March 9, 2001

Subject: Duke Energy Corporation  
Catawba Nuclear Station, Unit 2  
Docket Number 50-414  
Proposed License Amendment  
Revision of Unit 2 Reactor Coolant System Cold Leg  
Elbow Tap Flow Coefficients

**DESCRIPTION OF PROPOSED CHANGES AND TECHNICAL JUSTIFICATION**

### Figure 1

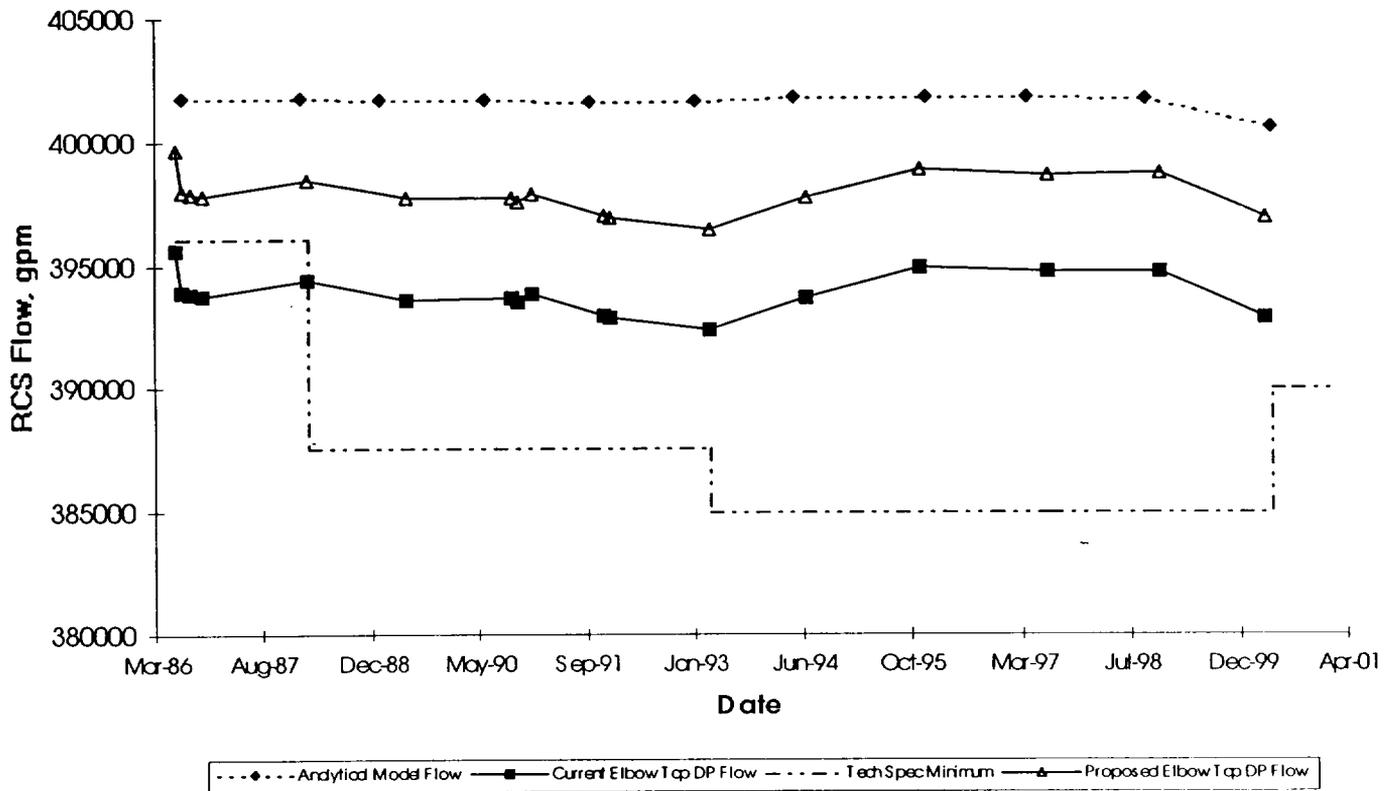
It is proposed to calculate a new set of elbow tap coefficients using a subset of the original calorimetrics to produce a new set of elbow tap coefficients with reduced impact from the later calorimetrics with large hot leg streaming penalties. This will produce a set of elbow tap coefficients that will be slightly higher than those currently used. The resulting indicated flow will be higher due to the removal of the excess conservatism in the current coefficient set. The seven most recent calorimetrics, those performed between June 1989 and April 1993, and one early calorimetric performed in August 1986 will be removed from the average to produce the new set of coefficients. The August 1986 calorimetric produced a flow which was slightly higher than that predicted by the analytical flow model and was therefore slightly non-conservative with respect to the analytical model (see Figure 2). This point represented a slight offset to the hot leg streaming penalties in the current coefficients and was removed since the slight non-conservatism would play a bigger role in the new coefficients, which have fewer penalties. The seven most

recent calorimetrics included in the current coefficients were removed since they contain a large fraction of the hot leg streaming penalties contained in the current coefficients. This will leave three calorimetrics performed between September 1986 and March 1988 included in the averaged elbow tap coefficient set. Of the three points used to produce the new coefficients, at least one contains a significant amount of hot leg streaming penalty to ensure these coefficients remain conservative with respect to the analytical flow model. The new set of calculated elbow tap coefficients are:

Using the delta P indications from the last RCS flow surveillance, and the new set of elbow tap coefficients, a new RCS flow rate of 396,907 gpm is calculated for the current cycle (Cycle 11). This represents an increase in the indicated flow rate of approximately 4,043 gpm or 1.0% of the Technical Specification minimum measured flow rate limit. Figure 1 shows the relationship between the current elbow tap indication of flow, the flow indication using the new elbow tap coefficients, and the analytical model prediction of flow. It can be seen that in Figure 1 the RCS flow using the new elbow tap coefficients generally mirrors the elbow tap flow using the current elbow tap coefficients, while providing approximately 1.0% additional flow margin. Figure 2 provides a plot of the Catawba Unit 2 calorimetric-determined RCS flow compared to the analytical flow model prediction of flow. In addition, this figure is annotated to describe the calorimetric-determined elbow tap coefficients used to determine the current averaged set of elbow tap coefficients and the new set of averaged coefficients.

|                | <b>Loop A</b> | <b>Loop B</b> | <b>Loop C</b> | <b>Loop D</b> |
| <b>Tap I</b>   | 0.30680       | 0.30313       | 0.31712       | 0.29936       |
| <b>Tap II</b>  | 0.29606       | 0.28601       | 0.29659       | 0.29929       |
| <b>Tap III</b> | 0.30382       | 0.30689       | 0.30389       | 0.30137       |

### Figure 2

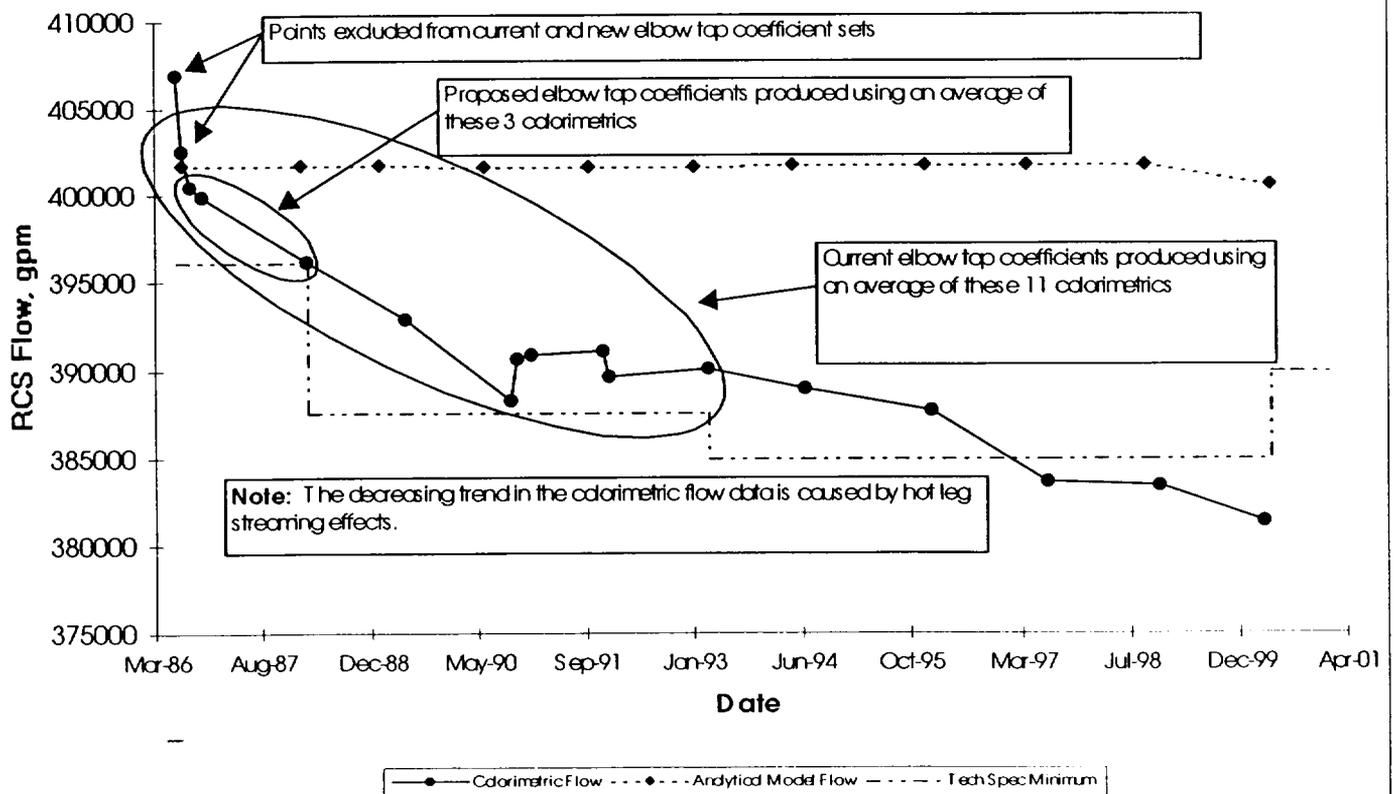
The elbow tap indication of flow was implemented to provide more predictability in the measurement of RCS flow over the previous calorimetric method of measuring RCS flow. The flow data gathered since the implementation of the elbow tap method of flow measurement has shown it to be a stable and accurate indicator of RCS flow changes. The current elbow tap coefficients, however, contain significant excess flow conservatism due to the method in which they were produced. The removal of some of the excess flow margin, which was introduced by the hot leg streaming flow penalties in later

calorimetrics, will allow additional margin between the indicated flow and the Technical Specification minimum measured flow limit. The proposed changes in the elbow tap coefficients will continue to be conservative with respect to the analytical model flow predictions, since the proposed elbow tap coefficients will continue to contain some hot leg streaming penalties from the calorimetric-determined coefficients used in the average. The indicated flow increase will accommodate any future flow decreases resulting from the upcoming core reloads containing Westinghouse RFA fuel, while allowing sufficient operating margin. Once the new elbow tap coefficients are implemented, the current flow margin to the Technical Specification minimum measured flow limit will be approximately 1.77%. The flow margins following the next two refueling outages are projected to be 1.29% RCS flow for the second reload of RFA fuel and 0.95% RCS flow for a full core of Westinghouse RFA fuel.
